GRPE A-LCA IWG SG5(EoL) Meeting 021

7th May 2025

A-LCA Drafting status

SG7 General comments for SG5

SG5 actions on SG7 General comments No.6

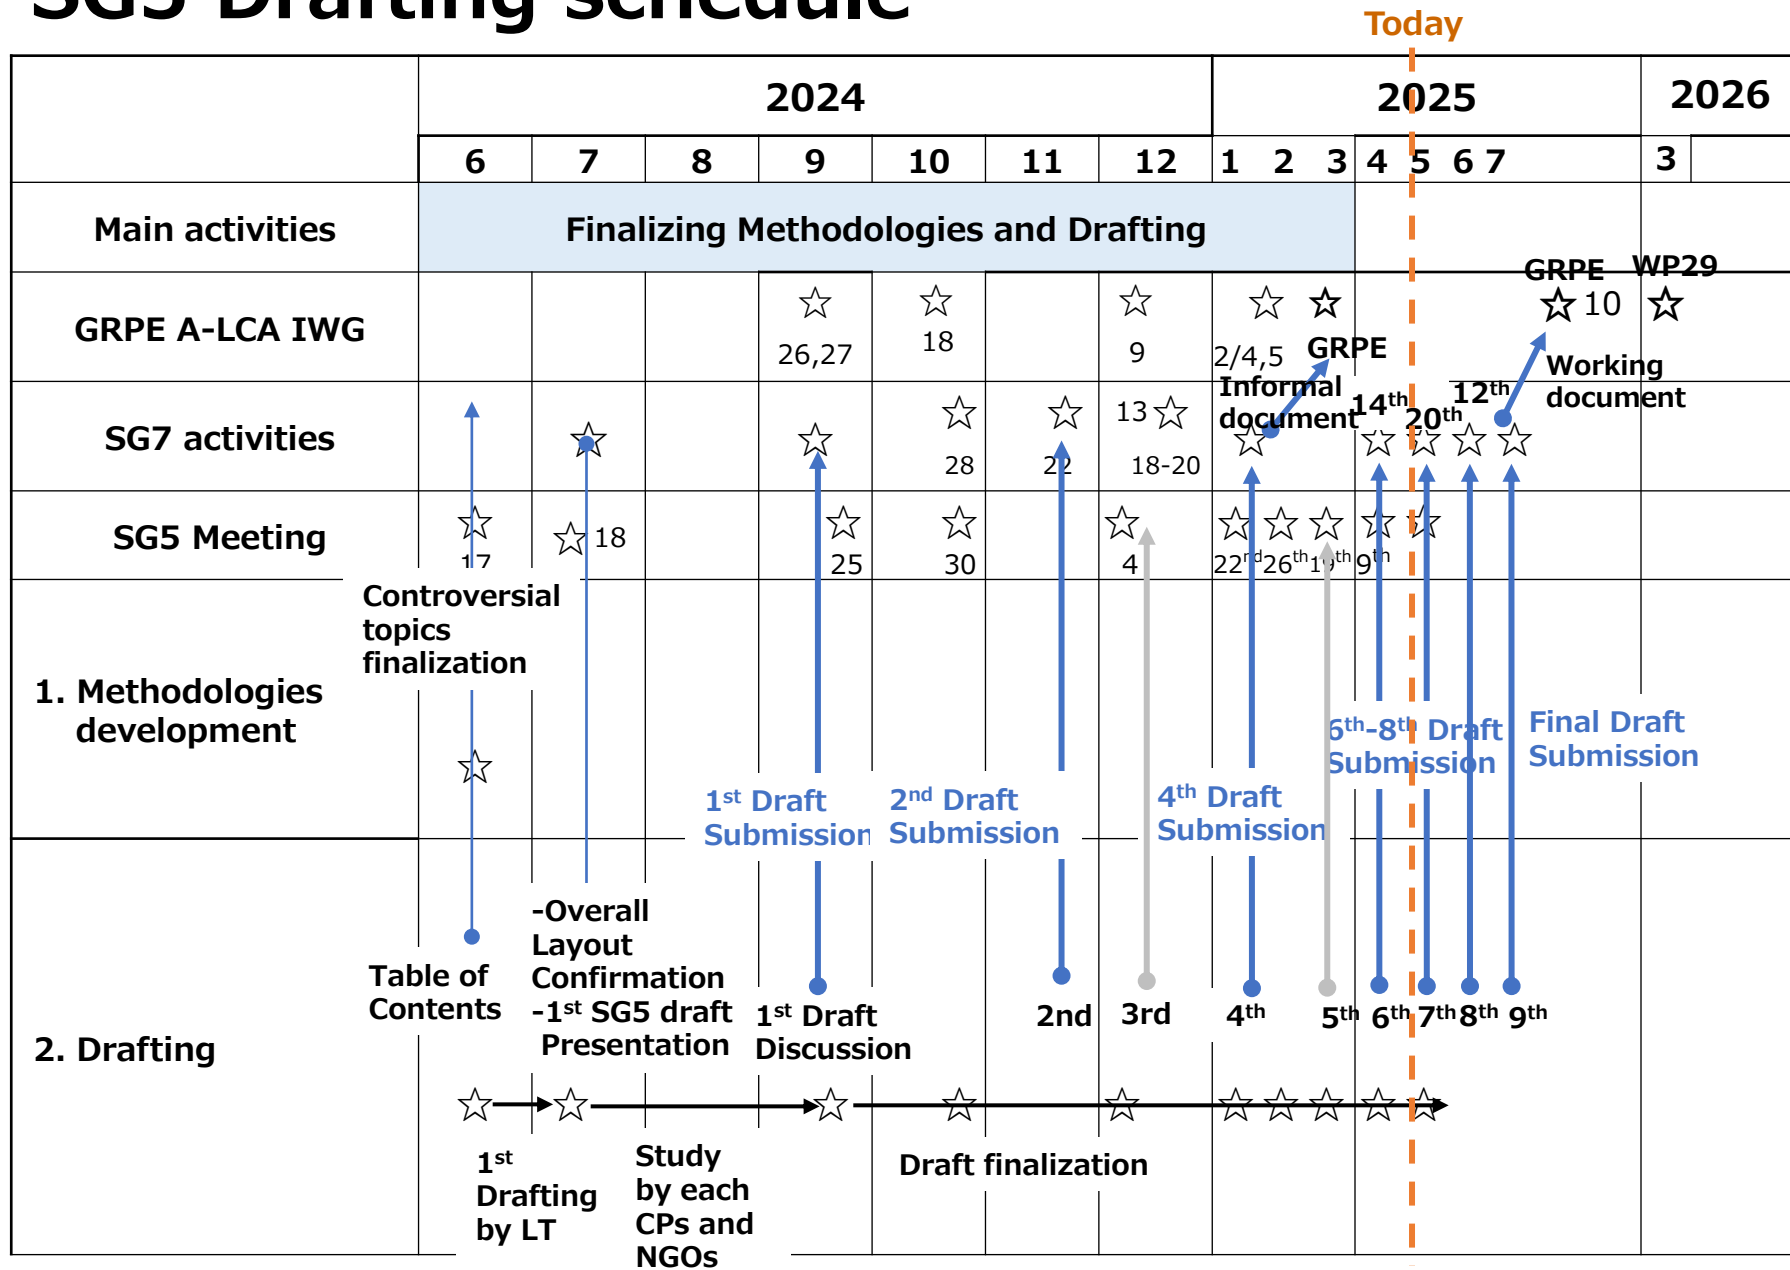
6. (f-2) secondary use : EF is mentioned : EF = Environmental Footprint (LCA European methodology) here ? I think that PEFCR battery and the European regulation on battery CO2 are divergent in term of methodology.

After the e-mail exchange with SG7 Caroline-san, she recommend to mention in the text that EF=Env. Footprint and corresponds to the EU LCA methodology.

- Change "EF" to "**Environmental Footprint (EF), LCA European methodology,**"
